MODIFICATION OF DEVELOPMENT CONSENT

**DA 234-08-01 – 44 Lot Rural Residential Subdivision
LOT 2 DP 848520
PACIFIC HIGHWAY, VALLA**

MAY 2010

Reference No: 030080
18 MAY 2010

Date. 30-4-2010 Drawing No. L-01 Rev. C

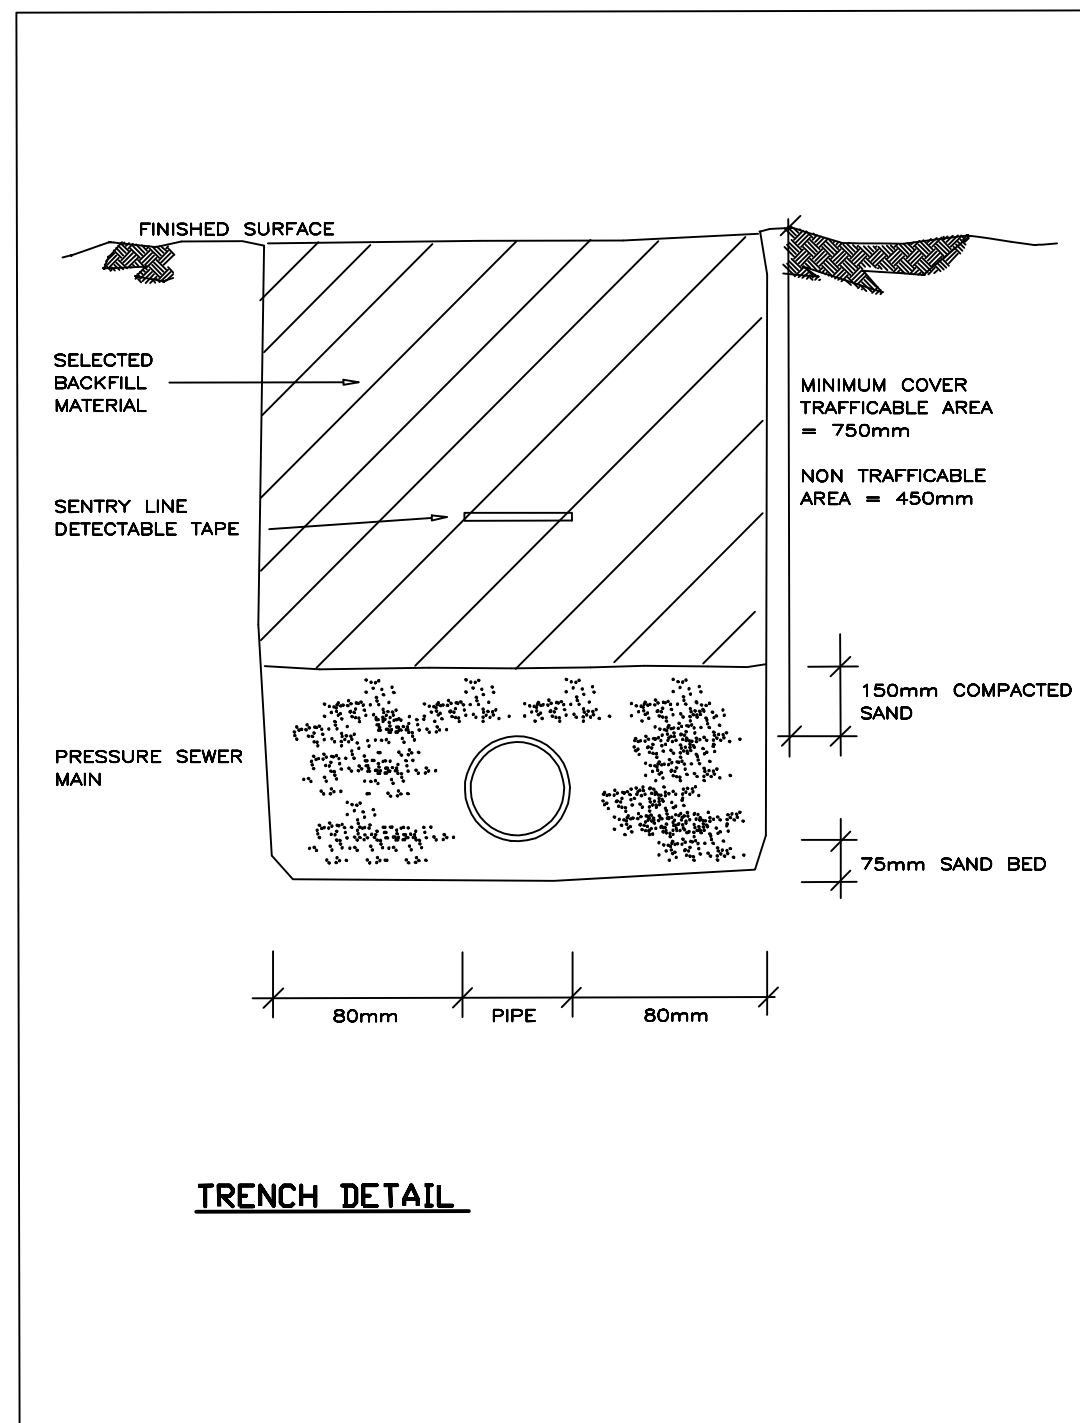
The revisions to Drawing L-01 involve the modification of a notation denoting the rural buffer on the southern boundary of the property as follows:

Approved notation: SOUTHERN BOUNDARY 80m SETBACK TO HABITABLE BUILDING FOR RURAL ACTIVITIES ON ADJOINING LOT.

Amended notation: SOUTHERN BOUNDARY 40m SETBACK TO HABITABLE BUILDING FOR RURAL ACTIVITIES ON ADJOINING LOT.

The revisions to Drawing L-01 involve the modification of the buffer notation on the eastern boundary of the property as follows:

Approved notation: 60m SETBACK FROM NORTH COAST RAILWAY TO HABITABLE BUILDINGS.

Amended notation: 40m BUFFER FROM NORTH COAST RAILWAY TO HABITABLE BUILDINGS IN ACCORDANCE WITH cl.87 OF SEPP INFRASTRUCTURE 2007.

- (i) Prohibiting **habitable** buildings within setbacks defined by drawings **L-01 REV.C** prepared by Smyth Maher and Associated Pty Ltd and de Groot & Benson Pty Ltd dated 11 November 2001 **and amended on 30 April 2010.**

- (i) Prohibiting **habitable** buildings within setbacks defined by drawings **L-01 REV.C** prepared by Smyth Maher and Associates Pty Ltd and de Groot & Benson Pty Ltd dated 11 November 2001 **and amended on 30 April 2010**.
